13074
4 October 2013

**SECTION 75W MODIFICATION APPLICATION TO MP 09_0007 - RESPONSE TO ISSUES
STAGE 1 MOORE THEOLOGICAL COLLEGE RESOURCE AND RESEARCH BUILDING**

Arboricultural Assessment Report
Proposed Resource and Research Centre - Moore College, Newtown

1.0 BULK AND SCALE

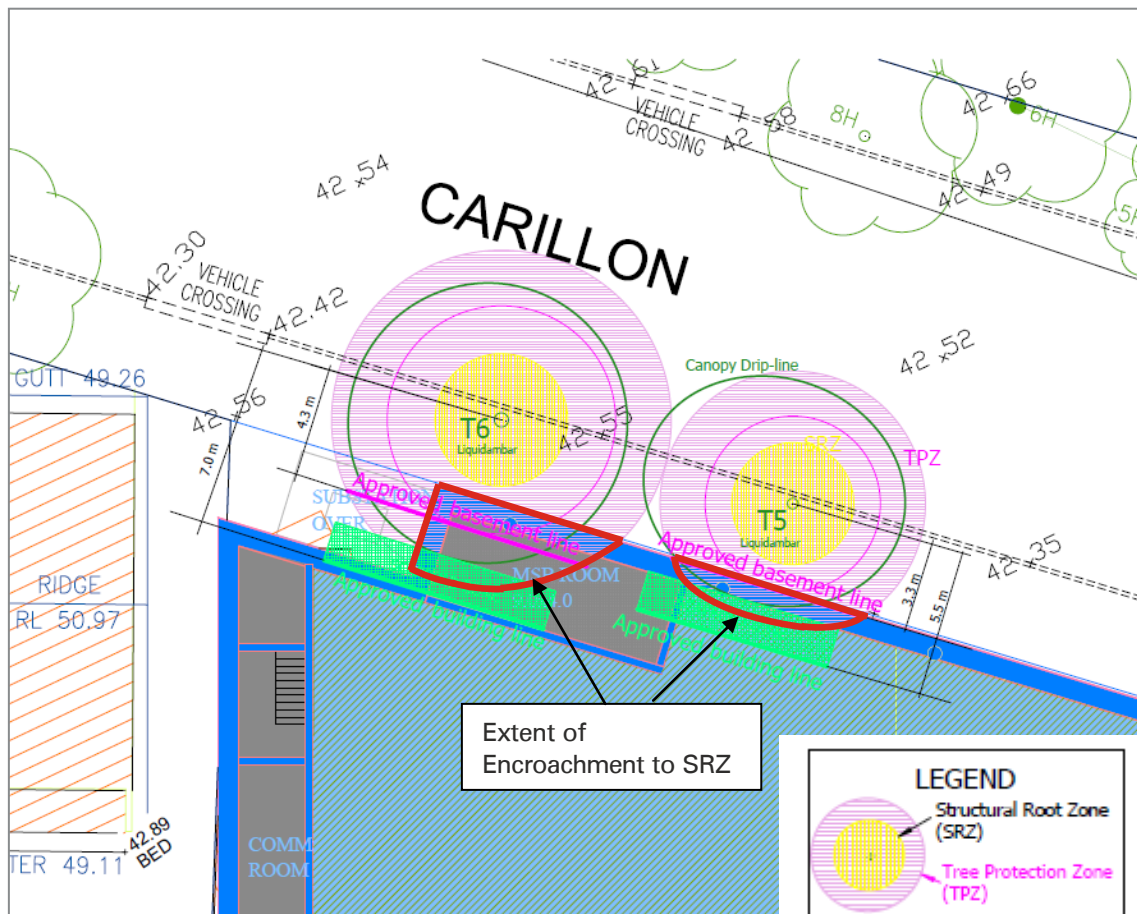
Moore Theological College understands Council's comments that the proposed plant will increase the bulk, scale and prominence of the building. However, Moore Theological College disagrees with Council's comments that the plant be reduced, as it has been designed specifically to meet the servicing needs of the development, whilst also achieving important project cost objectives which must be met if the development is to proceed. As outlined in the modification application, the proposed plant continues to comply with the approved Concept Plan's maximum permissible of height of 6 storeys and RL 70.6m. The plant is not wholly visible from all public areas and in fact will read as part of the building when viewed from City Road, and the shadowing impacts arising from the plant's location on the roof are no greater than those already deemed acceptable as part of the Stage 1 Project Application approval, and in some cases the modified design provides a reduced shadow footprint. Further, the plant has been suitably setback from the edges of the lower storey and a recessive colour choice has been made to further reduce the appearance of the plant.

The plant area has been predominantly located towards the southern edge of the building away from the Carillon and City Street frontages without providing any additional overshadowing to that previously approved.

APPENDIX 3
TREE LOCATION PLAN SHOWING
PROPOSED DEVELOPMENT
Moore College

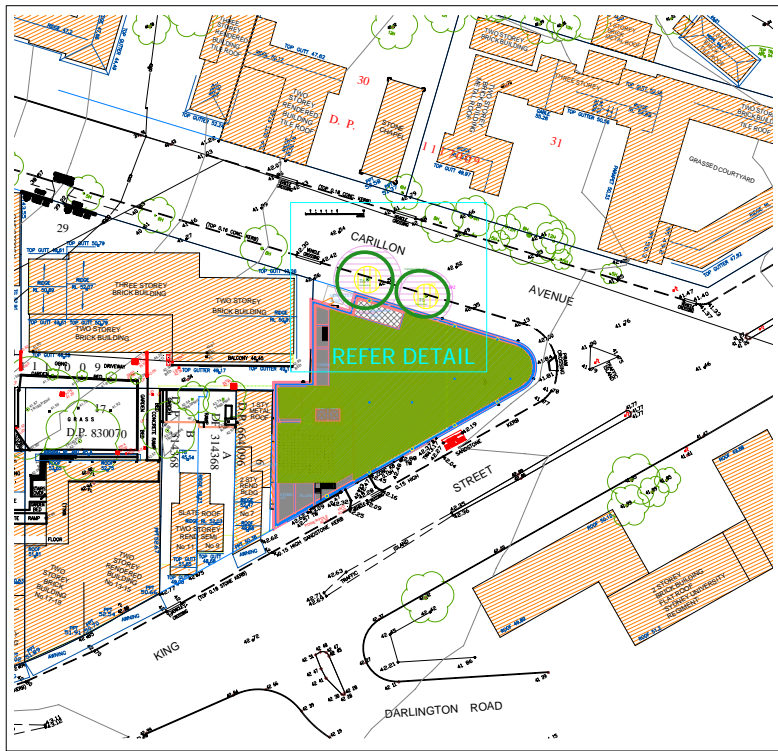
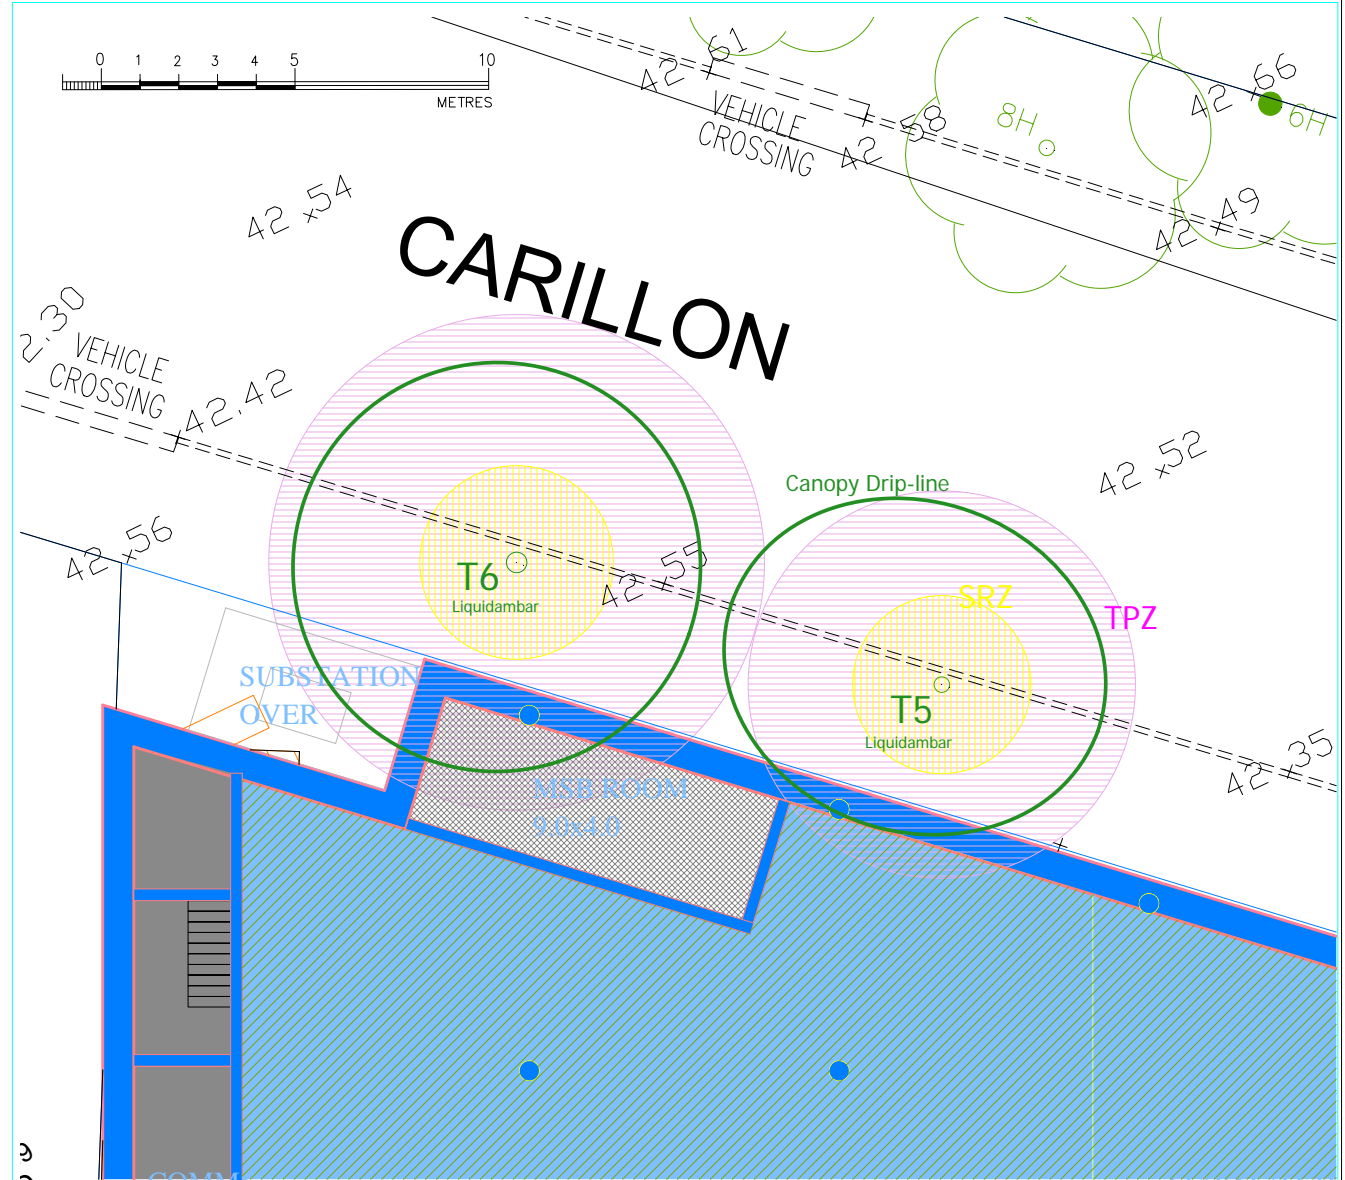
The proposed development includes the demolition of an existing building and construction of a multi-storey 'Resource and Research Centre' within Moore College near the corner of Carillion and Avenue and King Street, Newtown. The building includes a basement level. Excavations for the basement and a proposed substation will result in an encroachment to the TPZ's of T5 of approximately 12% and to

T6 of approximately 20%. This extent of encroachment exceeds acceptable limits under AS 4790:2009.

Whilst the report by Footprint Green indicates that both trees could be retained, in my opinion the proposed works would necessitate the removal of both trees due to the extent of pruning required. Significant modification of the building would be required to provide greater clearance from the canopy and root zones to permit the retention of these trees, which is not considered feasible in this instance.
